Subtask 2.3. Track, Signal and Grade Crossing

Requirement

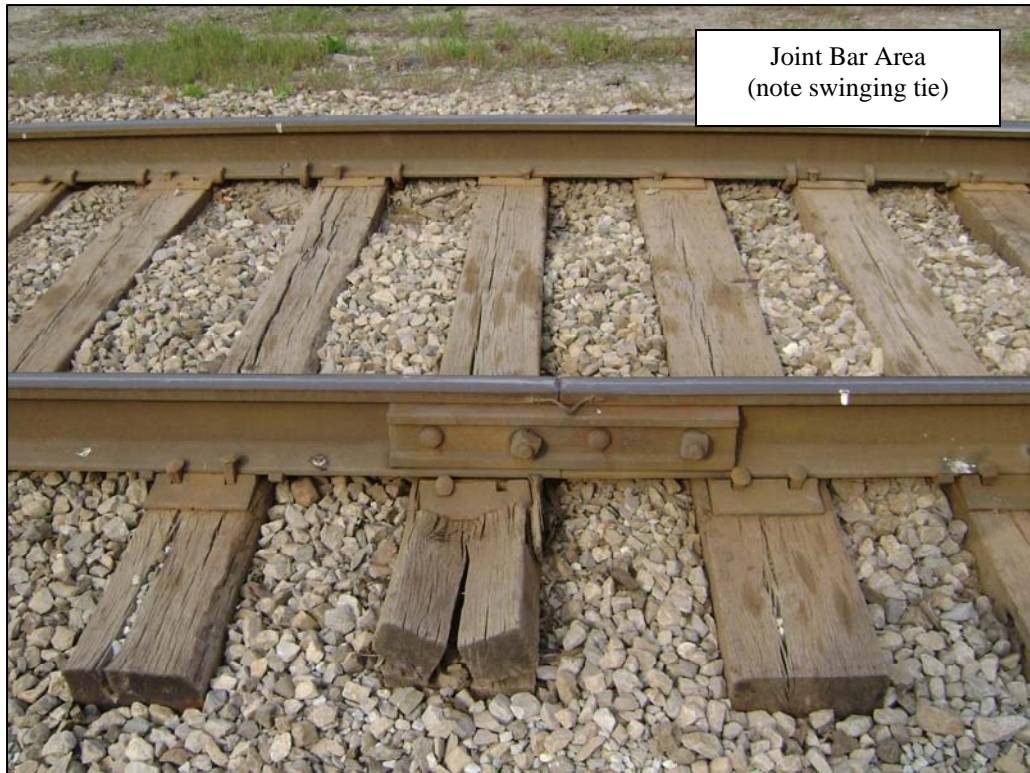
Additionally, a mid-day layover track is proposed to be constructed at the east end of Osmer Siding (see photo at top of next page) consisting of a hand-throw switch (off of the siding) providing access to a single 5,000 foot side track. Standby power would be supplied at this location as well. Access to this layover track would be by gravel road.

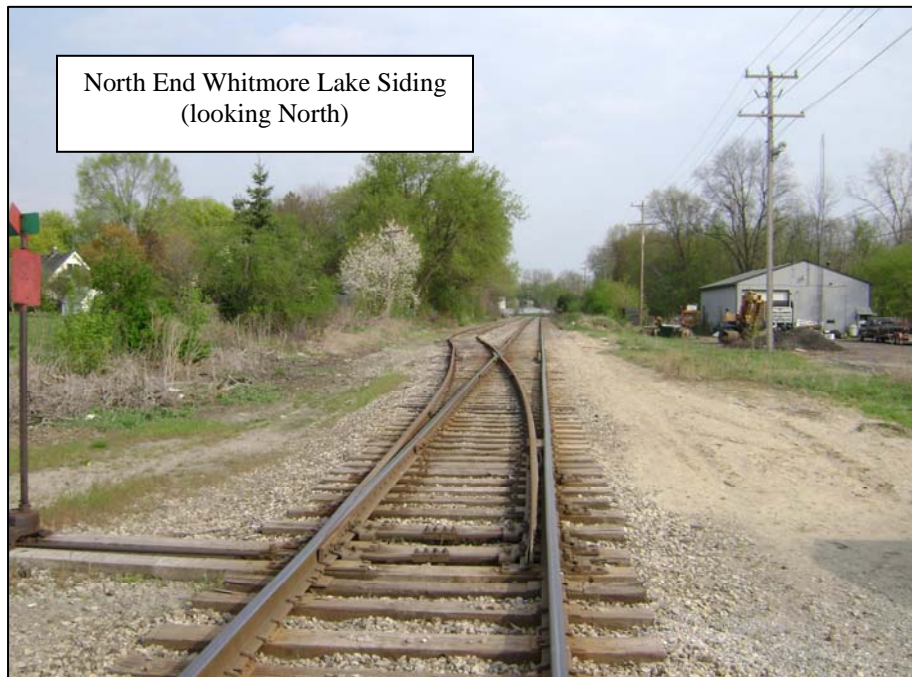
While RLBA was impressed with overall track condition, conversation with GLC representatives confirmed RLBA's initial assumption that some level of initial timber and surfacing (T&S) work will be required. That proposed T&S cycle would take care of situations such as those seen in the photo above. After all rail work is completed, RLBA assumes about 25 percent of the entire corridor or just under seven miles would receive a T&S cycle consisting of at least 600 ties per mile (out of about 3,200 ties in each mile) along with 1,000 tons of ballast per mile, for surfacing the track.

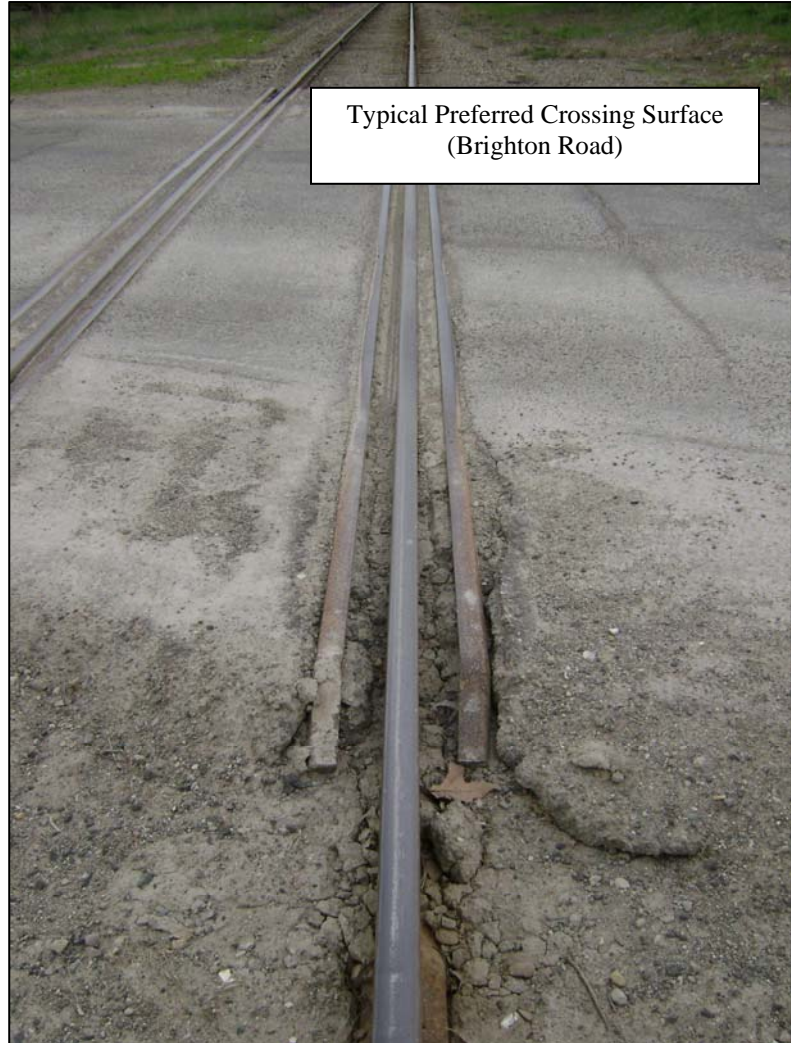
RLBA believes there are sixteen existing main track turnouts, such as the north end of Whitmore Lake Siding (see photo). RLBA estimates about 25 percent of the existing

main track turnouts would warrant replacement or renewal in conjunction with rail replacement and T&S work. Additionally, one new hand-thrown side track turnout would be constructed, providing access to the proposed mid-day layover track just off of the east end of Osmer Siding. Estimated capital costs are shown in the next section and
